UNITED STATES PATENT AND TRADEMARK OFFICE

Office Action Summary

09/864,925

EROMAKI, PENTTI JUHANI

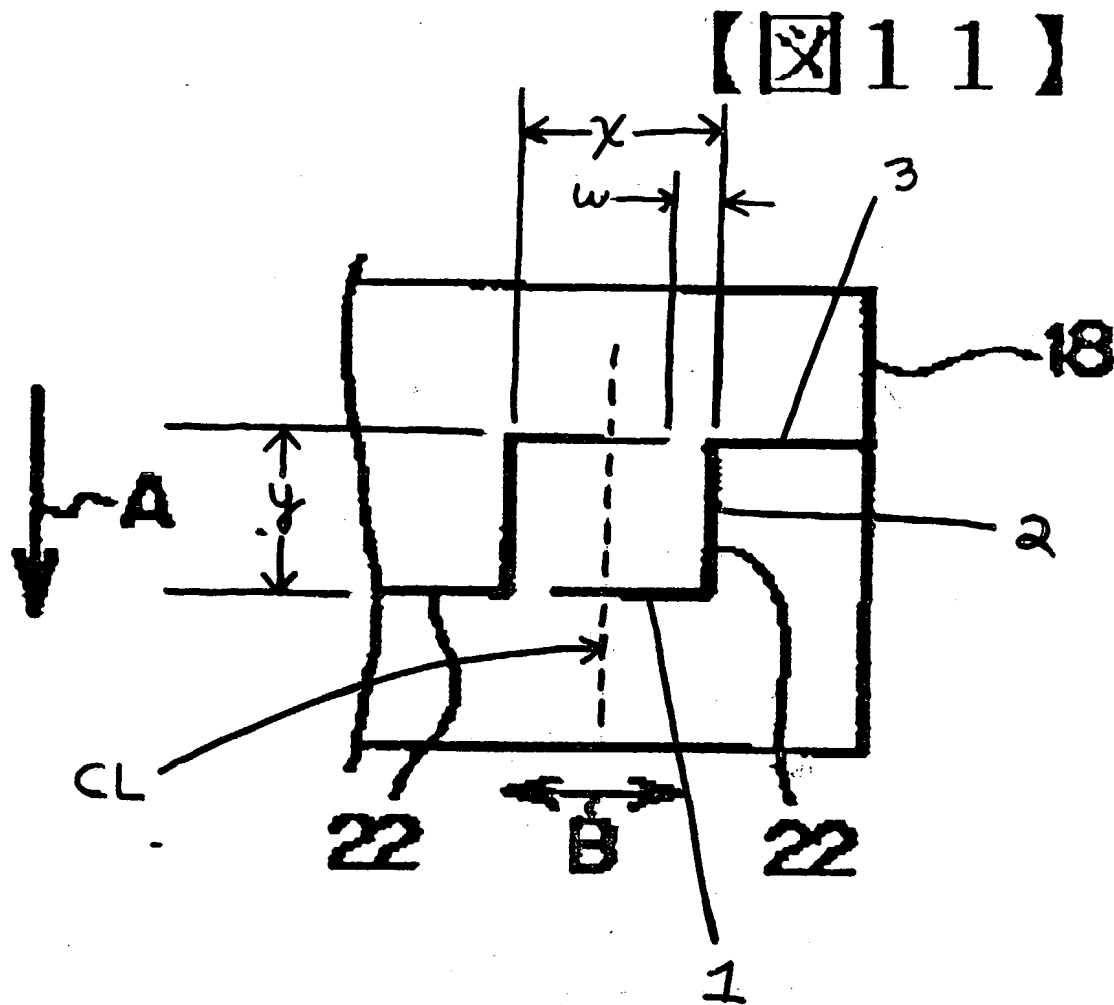
As to claim 1, applicant argues that the prior art does not teach a spacing at most five times the width of the sipes since the shortest spacing of the sipes in Caretta is six times the sipe width and the shortest spacing of the sipes in Japan '418 is eight times the width of the sipes. First: The issue is not the ratio of the "sipe spacing" (the spacing between the sides of sipes) to "sipe width". Instead the issue is the ratio of the "gap spacing" (the spacing between the end of one crank shaped sipe and the bend of another crank shaped sipe) to "sipe width". Second: Caretta and Japan '418 constitute evidence as to what the sipe width and spacings in Japan '710 can and should be. In order to facilitate discussion of the teachings of the applied prior art, an enlarged marked up copy of Japan '710's figure 11 is provided below:

The markings were added by the examiner. In figure 11, the circumferential sipe spacing" is y, the transverse sipe spacing is x and the gap spacing (the width of the web) is w. If the sipe width is 0.5 mm, a gap spacing w of 2.5 mm or less satisfies the claimed limitation of "at most five times". If the sipe spacing x is 4 mm, then the gap spacing w must be less than 2.5 mm since (1) 50% of sipe spacing x is 2 mm and (2) as can be clearly seen from the marked up copy, the gap spacing w is less than 50% of sipe spacing x. As to a sipe width of 0.5 mm, Japan '710 teaches that figure 11 shows

sipes 22 and Caretta and Japan '418 suggest using a sipe width of 0.5 mm for sipes.

As to a sipe spacing of 4 mm, the sides of the sipes 22 in figure 11 are spaced from each other and Caretta and Japan '418 suggest spacing the sides of sipes by a distance for example of 4 mm.

As to claim 23, applicant comments that conventional tires do not have webs whereas claim 23 requires webs which maintain block rigidity. Examiner comments the overlapping crank shaped sipes in Japan '710's figure 11 define a "web" which like that of applicant has a width equal to the small gap spacing and a thickness equal to the sipe width. Since Japan '710's webs have the same structure as applicant's webs, the Japan '710 webs have a decreasing web height as claimed.
